PUBLIC NOTICE AMENDMENT REQUEST

The permittee for P/N# OCRM-07-076-M, George McKee, has requested an amendment to that issued permit. Specifically, the applicant proposes to enlarge the permitted boatlift from 12.5' x 12.5' to 12.5' x 15.5', relocate it from the floodside of the existing dock to the ebbside, add a 3' x 15.5' catwalk to provide access to the boatlift, add a new 5' x 6' section to the existing 12' x 28' pierhead, and reduce the existing 8' x 30' floating dock to 8' x 25' to meet dock size limitations. The purpose of the proposed activity is for recreational use. The proposed amendment is for modifications to a private dock on and adjacent to Bohicket Creek at 3292 Bohicket Rd., Johns Island, Charleston County, South Carolina.

ORM-07-076-M Amendment

TYPICAL CROSS-SECTION MODIFICATIONS TO PRIVATE DOCK

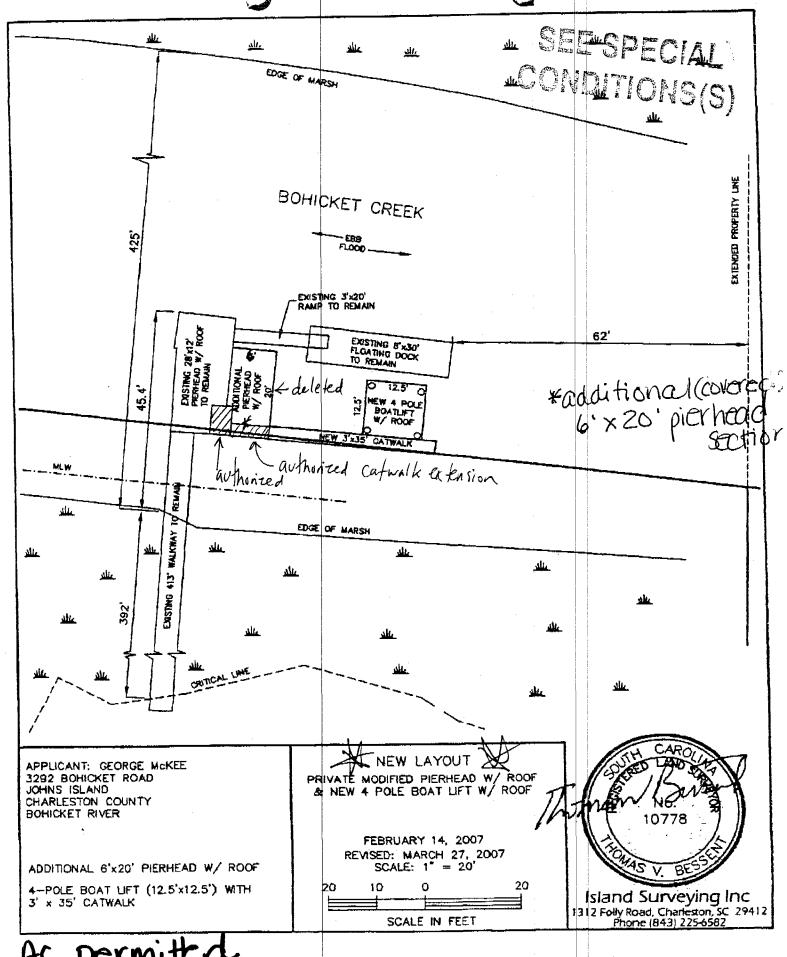
NEW 4-PILE BOAT LIFT (15.5'x12.5') WITH 3' x 15.5' CATWALK

MODIFY FLOATING DOCK TO 8'x25'

ADDITIONAL 6'x5' TURN AROUND
